December 17, 2021

CWE 2210655.01R

**Subject: Change of Geotechnical Engineer of Record and Update
Apartment Project, 2532-2542 Ridgeway Drive, National City, California**

SITE PLAN AND GEOTECHNICAL MAP

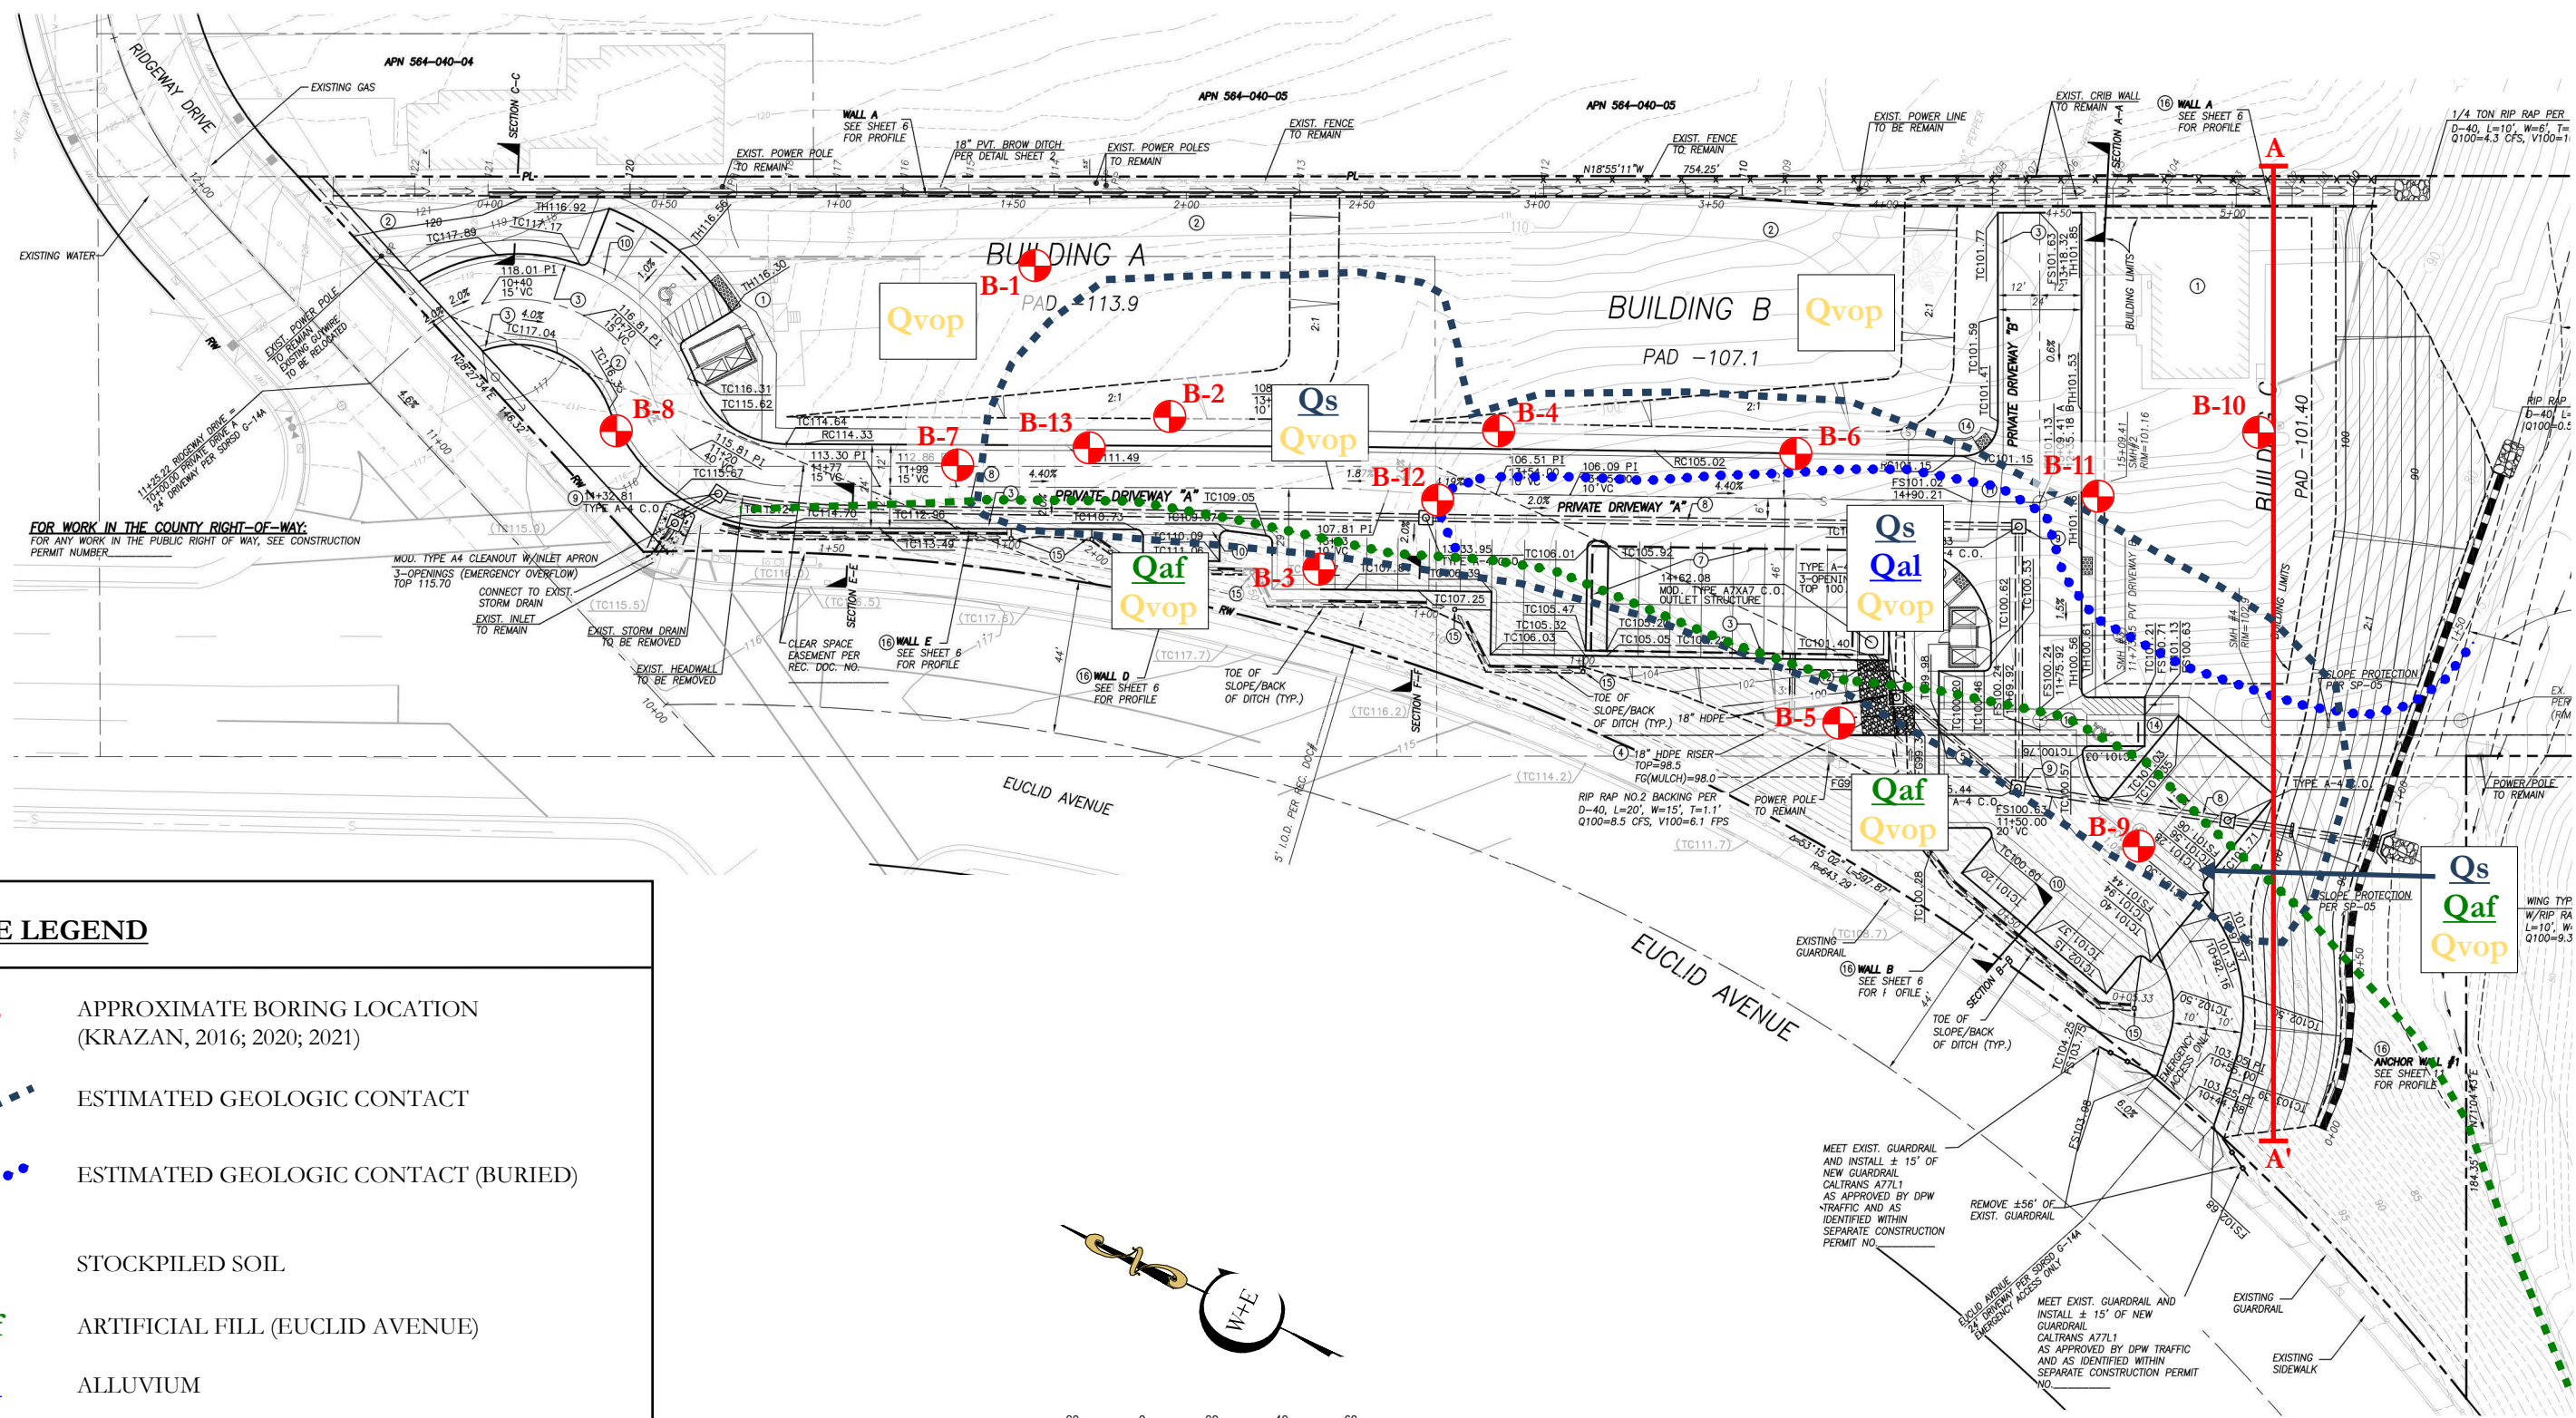
The subject site is located in the Coastal Plains Physiographic Province of San Diego County. Based on our review of the referenced geotechnical report, available geotechnical literature, and our experience within the vicinity of the site, we expect that the subject site is underlain by Quaternary-age very old paralic deposits that are overlain by artificial fill associated with the construction of Euclid Avenue along the western boundary and by surficial soils within the lower portions of the existing canyon. The surficial soil consists of both natural alluvium at the bottom of the canyon as well as stockpiled soils that have been imported from off-site. The estimated geologic contacts are shown on the Site Plan and Geotechnical Map provided herewith as Plate No. 1 and Geologic Cross-Section A-A' presented as Plate No. 2.

CANYON SUBDRAIN DETAIL

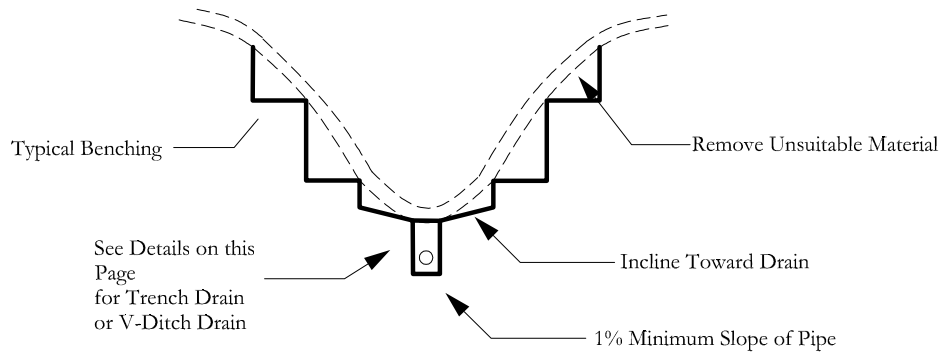
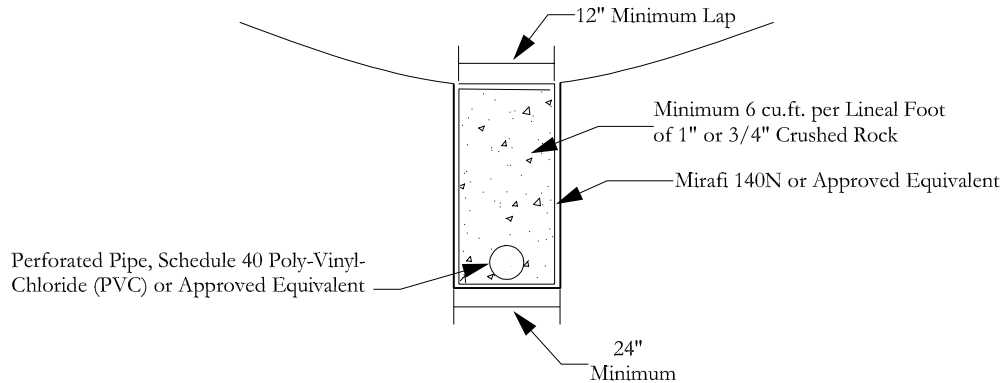
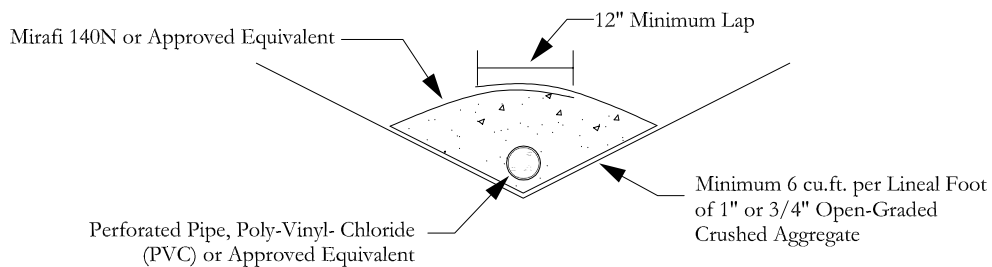
- A subdrain should be placed at the invert of the existing canyon after the surficial soils have been removed to the contact with competent very old paralic deposits. The subdrain should be extended along the bottom to the point where the planned fill thickness is 10 feet or less. Typical subdrain designs for canyon drains are detailed on the attached Figure 1. Subdrains should be outletted into storm drain pipes or into controlled drainage areas. Subdrains outletted into controlled drainage areas should have a head wall installed at the end of the drain.
